**US Army Corps
of Engineers®**

**Facilities Condition Assessment
Guam Memorial Hospital
Tamuning, Guam**

08 April 2020

Executive Summary
Facilities Condition Assessment
Tamuning, Guam

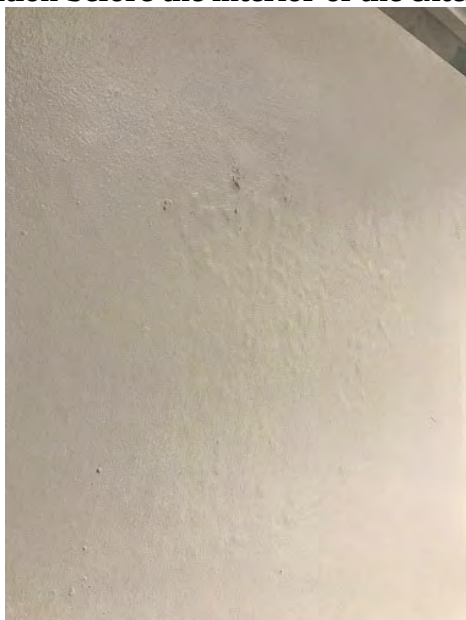
Exterior Windows (Flashing/Weeps/Caulk): Window sill flashing not provided and weeps at exterior are either not existent or sealed with caulk. Most architectural aluminum glazing system are not designed to be totally waterproof. Rather, most systems are designed to control water infiltration under extreme conditions and weep that water back to the exterior. Punched windows, storefront and curtainwall systems differ in many ways: appearance, profiles, wind loads, glazing, thermal performance and how they weep water. **Punched window** can be

operable or fixed which are located in a hole-like or predefined opening within the exterior wall. The most important consideration to understand is whether the window system is a rain screen or barrier system. A rain screen system provides internal drainage (weeps) for water that infiltrates into the system while a barrier system assumes that no water will ever infiltrate and does not need internal drainage. Fixed windows of course off the best resistance to air infiltration or water penetration and require less maintenance. **Storefront systems** control water infiltration by directing all moisture to the sill pan. It is imperative that the sill pan be installed correctly. Most manufacturers have prefabricated or can provide custom sill pan components with integrated end dams. Without end dams, water will intrude into the jamb locations of the building. Window perimeters should have flashing (head and Jamb) that are integrated with the waterproofing at adjacent walls. Water deflectors must also be installed wherever a horizontal mullion occurs. These direct water over to the vertical mullion where it weeps out at the sill flashing. Deflectors are necessary to ensure that the water bypasses the glass lite. Without water deflectors, moisture is likely to settle on the top of the glass, allowing water to enter the interior and causing possible failure of the glass unit. **Curtainwall systems**, we want to prevent water from reaching the vertical mullions. Each horizontal mullion must have zone dams properly installed and sealed at the vertical members. Any water that makes its way to the vertical mullion will ultimately make its way to the interior of the building. Unlike storefront, which directs water to the sill, curtainwall weeps water at each individual lite of glass through holes in the pressure plate. Because curtainwall systems are used for taller elevations with higher wind loads, the amount of water entering the system is typically greater than the capacity of storefront systems. This is why each lite of glass is individually weeped. Since water is not diverted down the vertical mullions to the sill, curtainwall does not require sill flashing. However, extreme care must be taken into consideration when installing caulk joints at the sill. The exterior caulk joint must be behind the face cover since water is weeping out of the bottom.

PRIORITY Repair: Recommend removing all of the existing windows across the entire facility and install newer high efficient non-operable (Fixed) Windows. High quality (marine grade, Kynar finish or stainless steel) aluminum framed windows are common, material is lightweight, strong, energy efficient and require little maintenance. Ensure that

the window framing system has a thermal break (i.e. nylon I beam) which prevents the frames from conducting heat/cold and eliminates condensation. Insulating laminated glazing units enhances acoustical performance, ultraviolet light protection and the laminated component is designed to remain integral in the opening should glass damage occur at the exterior layer. UV resistant and provide added protection for impact resistant glass for severe weather or blast protection. The glazing should have a low coefficient rating, multi-paned and low emissive glass (low-e coating) with glass panes bonded with a polyvinyl-butyl (PVB) interlayer.

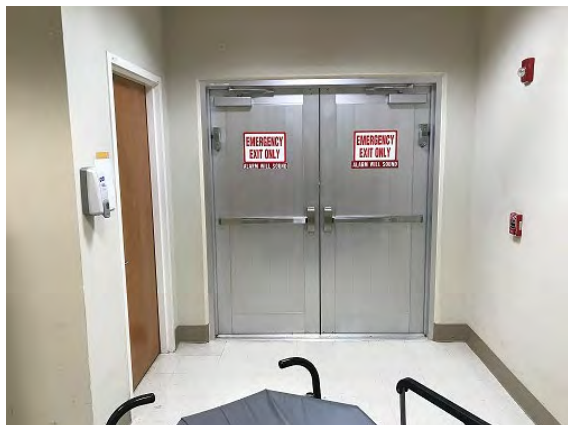
Exterior Wall Finish/Cleaning/Painting: The majority of the buildings has a significant amount of mold growth, peeling paint and discoloration on the exterior surface. The exterior wall itself appears to be in GOOD condition. Guam is located in a tropical extreme humid location. Although some of the mold may be located on the surface, other areas appear to be more significant. Mold feeds on organic materials, such as wood, paper, many fabrics, and even some types of glue. It literally eats away at these materials, causing them to rot and fall apart. Outside mold does not always stay outside. It will eventually find its way thru the envelope and into the building. Outside mold does carry health risks, but the risks are not as great as with inside mold. Although the concentration of mold will be less outside in the open air than it would be indoors. However, that doesn't mean exterior mold cannot lead to health problems. If someone

does spend time outdoors in areas with significant amounts of mold, one's health can be at risk. Children are particularly susceptible to mold-related health problems.

This mold may be caused from the moist humid conditions/environment, low quality paint, from an inferior, damaged or missing vapor barrier or simply the exterior materials used. Another influence, could be negative pressure rooms located at/near the exterior wall drawing the moisture into the building. Buildings in general should be positively pressured. The GMH facility is actually under negative pressure. **MAJOR SCHEDULED REPLACEMENT (MSR)**
Repair: Recommend that the entire exterior of the facility be sprayed with chemicals to kill the mold, power washed, then sealed, caulked and painted with a high quality mold resistant paint. Implement a mold prevention/ maintenance plan to clean the exterior regularly.

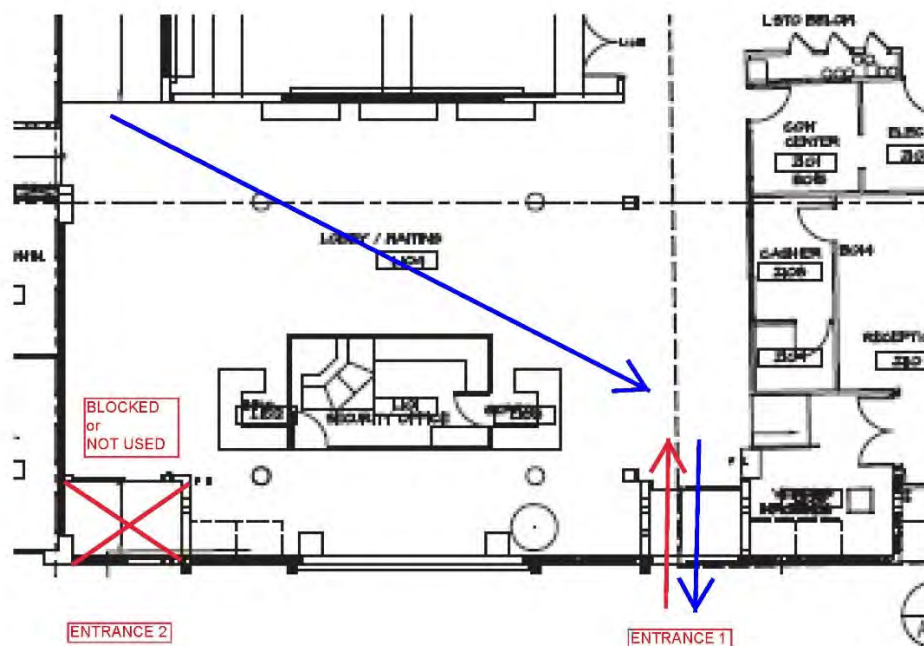
Front Entrance/Vestibules: The hospital front entrance vestibules has both an exterior and interior single sliding door configuration with possible break away feature. However, the door separation depth is only about 6 feet. Both sliding doors open simultaneously when someone approaches at either side (ingress or egress) allowing the hot, humid, moist outdoor air to gust/enter into the building. The arrangement, operation and separation does not function properly as both sets of doors are open simultaneously the majority of the time (duration of the day) due to the traffic conditions. The mechanical air curtain installed does not provide any assistance. The main contributor is that the second set of entrance doors, opposite side of the front entrance, are not in operation. This also significantly increases the egress capacity/occupant load at this single vestibule.

Vestibules are typically required for all medical facilities located at primary entrances. The depth of the vestibules shall comply with ABA requirements and should be sufficient depth to allow the outside doors to close before the inside doors are opened when someone passes

through. ABA specifies the distance between two hinged or pivoted doors in series shall be 48 inches minimum plus the width of the door swinging into the space or about 10 feet. ASHRAE 90.1 also requires a minimum distance of 7'-0" between closed interior and exterior vestibule doors. These minimum separation distance requirements are typically NOT sufficient. The automatic closing speeds of these doors can have a significant impact on door function, timing/sequence and passage. The distance separating the doors combined with a large number of personnel passing through, especially at shift change, can result in both sets of doors staying open continually. Vestibules are provided to reduce infiltration losses (or gains) from wind and stack effects by creating an air lock entry. This has been a recurring problem with most facilities. **PRIORITY Repair: Recommend (1) a building traffic study be completed to include "rush hour" entry and exit volumes to properly configure and size vestibules such that the automated doors are not continuously open. (2) both vestibules will need to be modernized to a greater depth (10 feet +/-) and install new doors, sensors for more ideal operation or sequence and possibly offset of doors/ opening (diagonal) in lieu of aligning. Alternative option for consideration would be a large revolving door with an emergency man door located at both entrances. EMERGENCY Repair: Recommend that the current closed, second vestibule be fixed and placed back in operation so one is dedicated to ingress traffic and the other egress. This would split the usage between two entrances, in lieu of one, reducing the wear and tear and air infiltration until they can be redesigned, reconfigured and updated.**

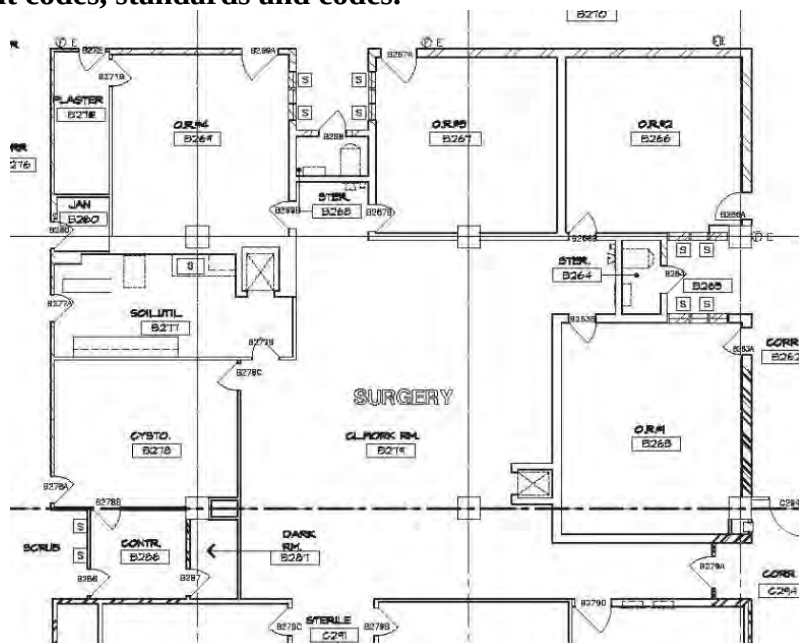
OR Layout: Although the current or existing OR room are functional, they are not compliant with today's newer standards for size, layout, clearance, equipment or flow as the design is outdated and does not comply with current codes or FGI guidelines. **MAJOR SCHEDULED REPLACEMENT (MSR) Repair: Recommend redesign of entire surgical**

suite/department for better flow, adjacencies, space allocation and upgraded OR's to current codes, standards and codes.

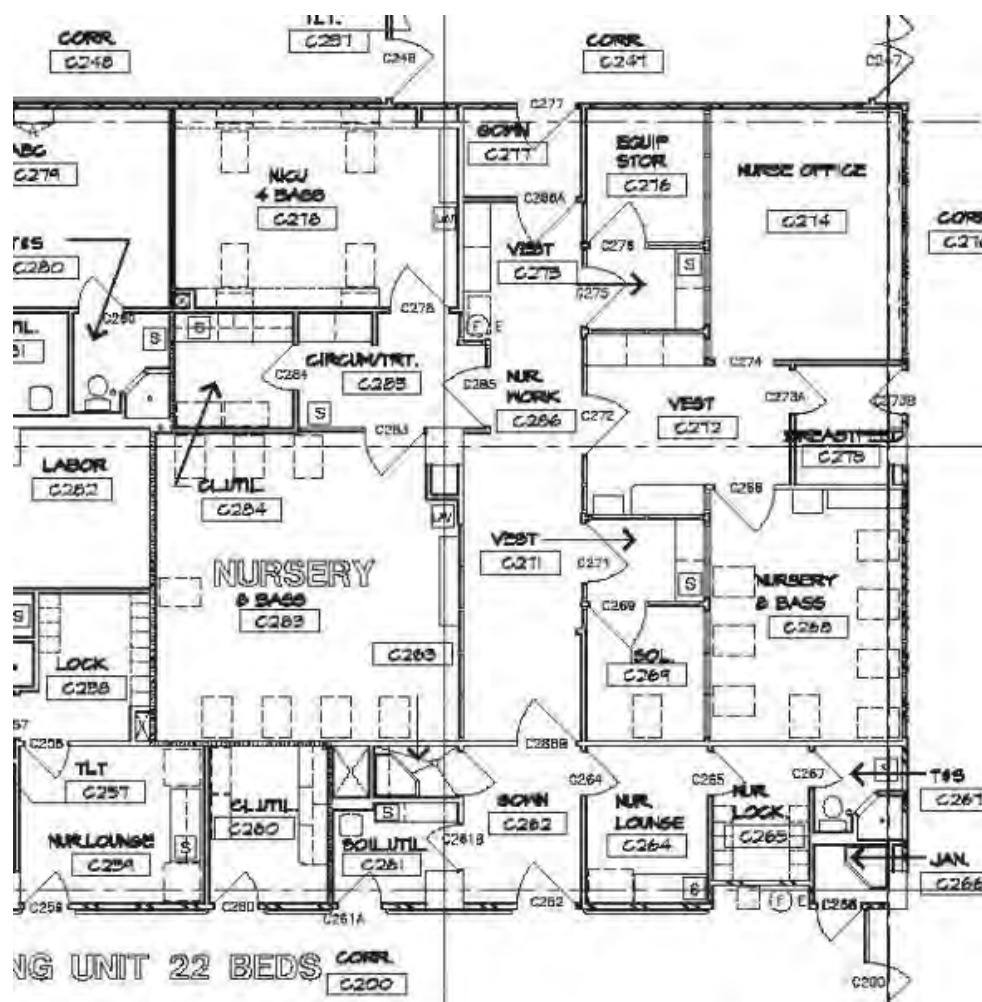
NICU Layout: Although the current or existing NICU rooms are functional, they are not compliant with today's newer standards for size, layout, clearances, equipment, light levels (controls) or flow as the design is outdated and does not comply with current codes or FGI guidelines. **MAJOR SCHEDULED REPLACEMENT (MSR) Repair: Recommend redesign of entire NICU suite/department for better flow, adjacencies, space allocation and upgraded nursery to current codes, standards and codes.**

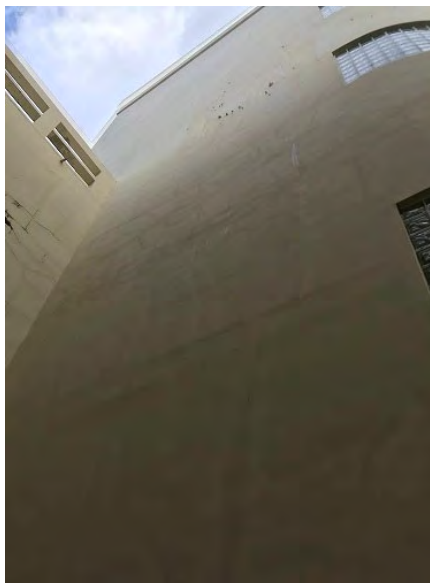
Exterior Stair Walls: Center stair enclosures (#2 & #3) at both north and south ends of building have infill poured in place concrete walls which have significant cracking issues and settlement. A project is currently underway replacing the glass block windows due to failure of rebar and leaks. **PRIORITY Repair:** Recommend that a full in-depth structural analysis be conducted on the walls and foundation supporting these stairs. The wall cracks may be injected with epoxy to bond and seal the cracks within the exterior wall. The foundation may need to be expanded/enlarged, reinforced and or even replaced. The foundations could be jacked up/lifted then added concrete could be added for stability and support meeting current seismic requirements.

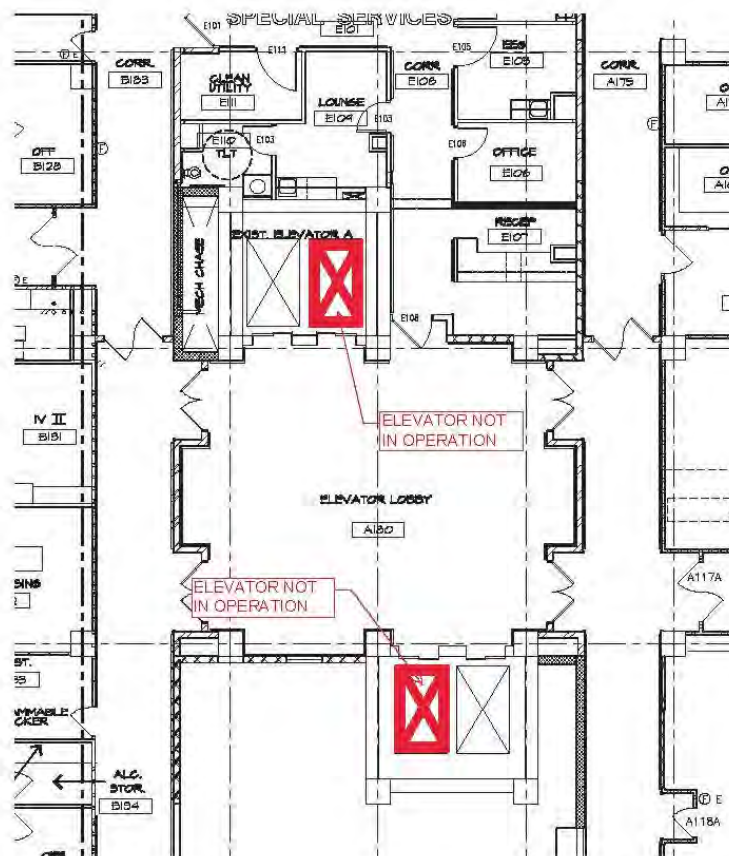
Elevators: Two of the four elevators for the facility were down, not working and under significant repair. Another was down for a short time for maintenance related repairs. The facility did have ISLM in place for the elevators. There is a current awarded project to modernize and replace the existing elevators (motors, gears, ropes, controls, etc.) and update the car/cabs to current standards. (LS03.01.50, NFPA, IBC, etc.) **PRIORITY Repair: Recommend getting this project started as soon as possible to get all elevators up in operation. Elevators are essential for moving patients to/from upper floors and critical departments. Keep all ILSM's in place throughout the construction phase.**

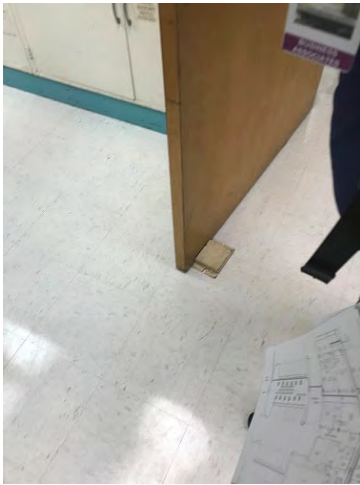
PT Corridor doors propped Open: Three rooms located on the first floor (A-Wing) Physical Therapy (PT) had the corridor doors propped open with a floor door wedge or by equipment. Occupational Therapy A116, Clean Utility A115 and Treatment A113. Corridor doors are required to latch LS.02.01.30 EP 11, 12, 14 and LS.02.01.20 EP 11, EP 32, EP33 , EP34.

EMERGENCY Repair: Recommend removing any door wedges or items that hold the door open that is not code compliant. Only use approved/ authorized methods for holding doors open like magnetic hold devices or other types of approved hardware door hold open devices.

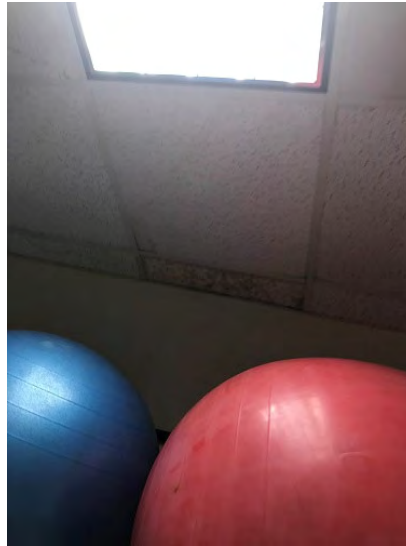
Fire Extinguisher Height (PT Corridor A112): Handle of fire extinguisher is higher than 60 inches. Portable fire extinguishers shall be selected, installed, inspected and maintained in accordance with NFPA 10, Standards for Portable Fire Extinguishers. TJC Environment of Care (EC.02.03.05 EP10, EP15 and EP16) fire extinguishers to be installed 4 to 40 inches AFF (top of cabinet or handle). NFPA 10, Section **6.1.3.8.1** Fire extinguishers having a gross weight not exceeding 40 lb (18.14 kg) shall be installed so that the top of the fire extinguisher is not more than 5 ft (1.53 m) above the floor. **PRIORITY Repair: Recommend removing bracket and reinstalling FE at appropriate height**

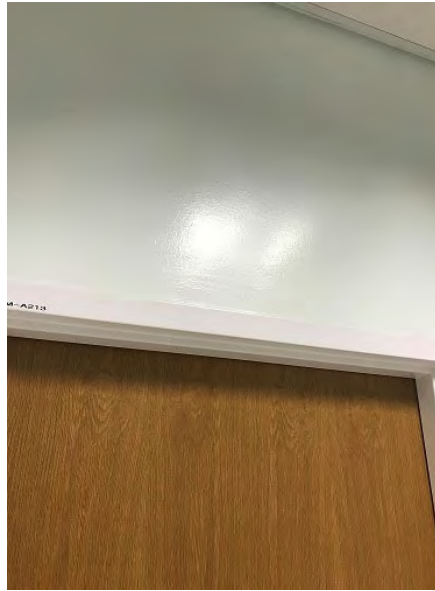
ED Equipment Alcove Wall Damage (F201): Walls have excessive damage due to carts, equipment and/or beds. Drywall no longer has protective qualities or painted surface which now exposes the inner core. Blood or other fluids along with dust and mold can now be easily absorbed into these damaged areas creating a high risk and infection control risk. (EC.02.06.01 EP20) **MAJOR SCHEDULED REPLACEMENT (MSR) Repair: Recommend to Patch and paint damaged walls. Then install wall protection treatment such as acrovyn/FRP panels for durability, impact resistance and easy cleaning.**

ED Door Frame Damage (F202): Door frame has excessive wear due to carts, equipment and/or cleaning agents used. Frame no longer has protective qualities with painted surface which now exposes the bare metal. (EC.02.06.01 EP20) **MAJOR SCHEDULED REPLACEMENT (MSR) Repair: Recommend painting frames. Additional added protection would be to add door frame protection acrovyn/FRP/stainless steel products for durability, impact resistance and easy cleaning.**

Water cooled chiller

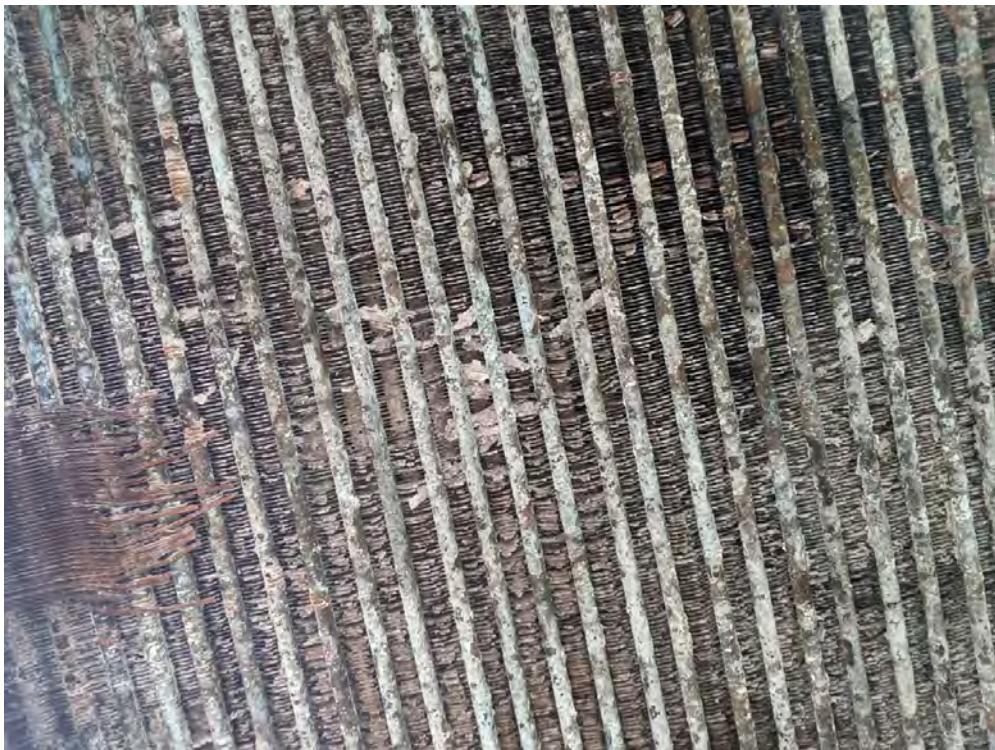
Based on the as-builts the chilled water supply set-point is 42 deg F; however, the chillers are providing a 44 deg F supply temperature. While this difference did not seem to effect the ability of the system to maintain temperature and humidity in the patient care areas at the time of the survey, this difference could contribute to the high humidity reported when the ambient weather approaches design day conditions.

Inadequate exhaust in sterilizer equipment room

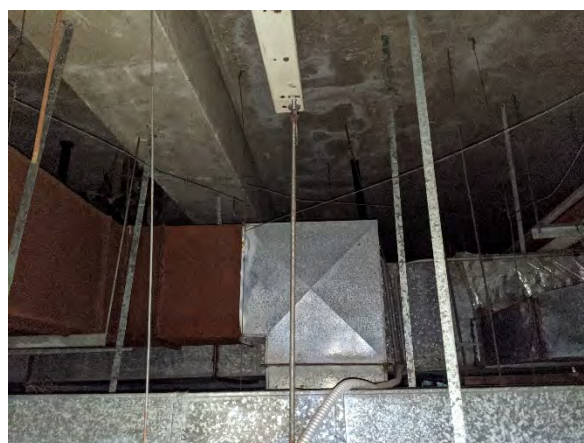
New double sided pass through sterilizers have recently been added between the clean work room (assembly/prepack) and sterile storage similar to a three room sterilization suite. This is an industry accepted best practice. However, it does not appear that the HVAC system was upgraded to comply

with current requirements for the sterilizer equipment space created with this change. ASHRAE STD 170 requires this space to have 10 ACH, be at a negative pressure, and all space air exhausted directly to the outdoors. Currently to keep temperatures within the space under control, the access doors are propped open and fans are positioned to circulate air in the space, and based on the size of the exhaust diffusers in the space, it does not appear that sufficient exhaust is being provided to meet the required ACH rate.
